Attachment to notice of Intention to Abandon

Well: Alamos Canyon 10

Well No.	Alamos Canyon #010	SHL	945	FNL	1650	FWL
API No.	3004320526		Unit C	Sec. 09	T21N	R06W
Lease No.	NMNM21454	BHL	Same			
Operator	M & M Production & Operation					
Elev. (GL)	6819	County	Sandoval		State	NM
Total Depth	1590	PBTD	1523	Formation	Chacra

Alamos Canyon #010

Proposed Wellbore Diagram

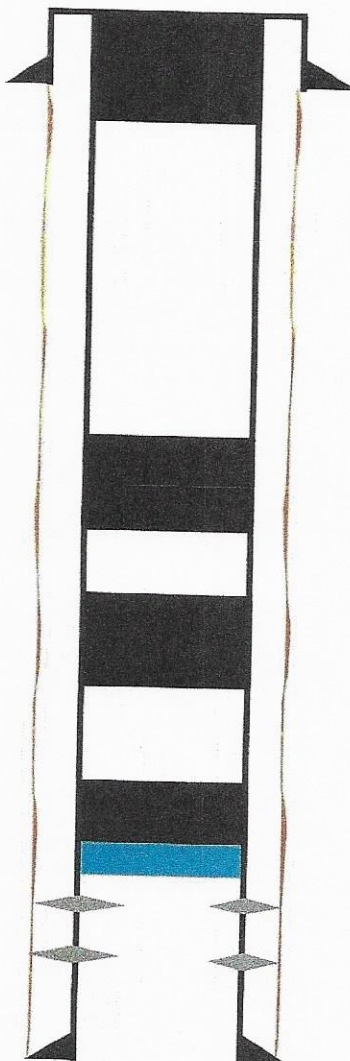
- Holcomb Oil and Gas, Inc. plans to plug the subject well as Record Title Owner of the lease.
- Chacra perfs 1382' - 1422'.
- Recommend running a CBL.
- Adjust Plug #3, or add a plug, to ensure that the Fruitland (760'), Kirtland (675') and Ojo Alamo (430') tops are all covered.
